EXHIBIT C

Specific Responses to October 4, 1976 Letter from
D L Ziemann to L O Mayer

DESCRIPTION Ltr notarized 11-10-76...trans the following PLANT NAME: Monticello	ENCLOSURE Amdt to OI/Change to Tech Specs: Consisting of revisions with regard to drywell to suppression chamber differential pressure re our 10-4-76..... (40 cys encl rec'd)
---	--

Figure C-1. Nitrogen Recirculation System

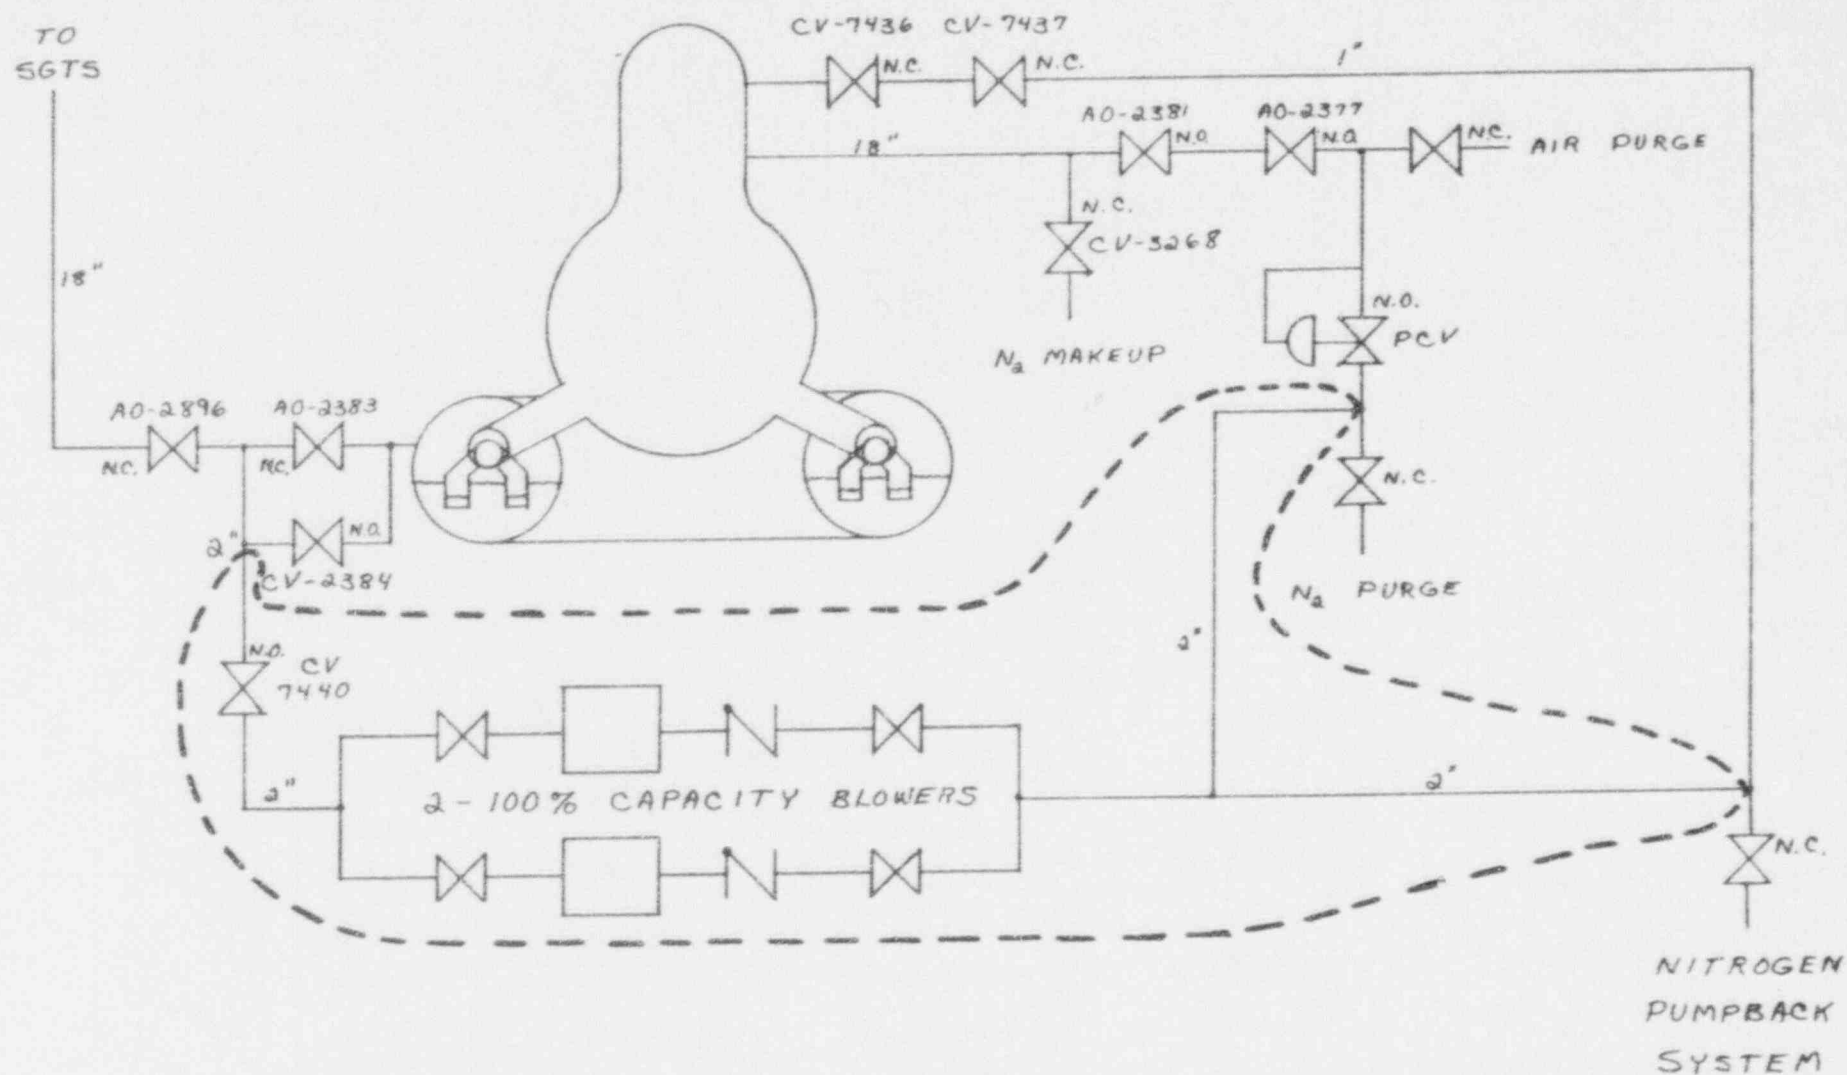
This subject is addressed in the April 14, 1976 License Amendment No 18 to DPR-22 which issued the Technical Specification Changes necessary to implement the Monticello nitrogen recirculation equipment. The attached Figure C-1 shows the nitrogen recirculation system identifying the newly added equipment. Containment isolation valves are identified by their unique numbers. The License Amendment acknowledged the addition of a normally open isolation valve, CV-7440. It also acknowledged that three isolation valves, the torus vent bypass valve, CV-2384, and the drywell purge inlet valves, AO-2381 and AO-2377, were changed from normally closed to normally open.

The nitrogen recirculation system removes nitrogen from the torus via CV-2384 and CV-7440 using one of two 100% capacity blowers. The blower will discharge nitrogen through the drywell purge inlet line to the drywell via AO-2381 and AO-2377. Recirculation flow is manually adjusted to maintain the drywell pressure greater than or equal to 1.0 psi above the torus pressure. The system up to the second containment isolation valve in the suction and discharge lines satisfies all design, quality assurance, and testability requirements set forth in 10 CFR 50.

The added isolation valve, CV-7440, receives motive power from instrument air, failing closed on loss of air. The circuitry used is the same as that used throughout the plant on outboard air operated isolation valves. A solenoid valve is energized to open the valve. The solenoid is de-energized by an isolation signal or loss of the instrument bus associated with outboard valves. A detailed discussion of the scheme used can be found in Monticello FSAR Section 7. There is no potential for high energy line break pipe whip or missiles in the vicinity of CV-7440.

Figure C-2. Primary Containment Instrumentation

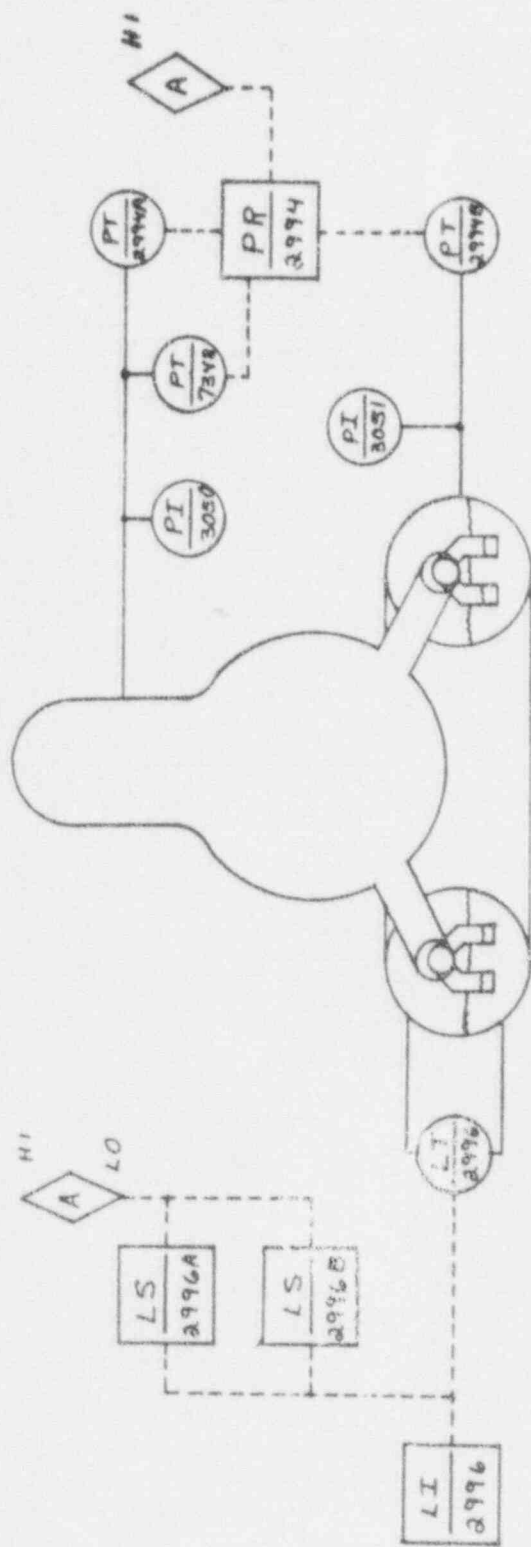
The attached Figure C-2 shows the instrumentation available to measure the drywell to torus differential pressure. The pressure sensing lines to the main transmitters are supplied with local indicators PI-3050 and PI-3051 which have a 0 to 100 psig range. The pressure signals used to monitor the 1 psi drywell to torus differential originate at pressure transmitters PT-2994 A and B which have $\pm \frac{1}{2}\%$ accuracy over the 13 to 17 psia range. These signals are displayed in the control room on a dual pen 4" recorder, PR-2994, which also has an accuracy of $\pm \frac{1}{2}\%$ of span. (The drywell pressure pen can be switched to a wide range scale in the event of a drywell pressurization; pressure transmitter PT-7348 provides a 0 to 30 psig input to the recorder.)

The operator maintains the 1 psi differential by maintaining at least one inch separation between pens. The ultimate accuracy in maintaining the 1 psi lies in the ability to read the chart. The chart-reading error is within 1/16 inch which corresponds to 0.06 psi.

The single channel of instrumentation available to monitor the drywell-torus differential pressure is independent of the pressure switches used for ECCS initiation signals.

The torus level instrumentation available is shown in the attached Figure C-2. This is a single channel system initiated by level transmitter LT-2996. Level indication in the main control room is provided by LI-2996; high and low level alarms in the main control room are initiated by level switches LS-2996 A and B.

Level indicator LI-2996 has an accuracy of $\pm 2\%$ across its $4\frac{1}{2}$ " display of the range of -15" to + 15". Level switches LS-2996 A and B provide high and low torus level alarms at the levels of -1" and -2 $\frac{3}{4}$ ", respectively. (This range is selected to keep the torus level, and therefore the dynamic load resulting from a reactor blowdown, to a minimum.) Both the level indicator and the switches are fed by level transmitter LT-2996. The level transmitter and switches are $\pm \frac{1}{2}\%$ devices over the 30" span. The combined error of the alarm setpoint is therefore ± 0.2 ". Through the indicator and the alarms, the operator has available continuous monitoring of torus water level.
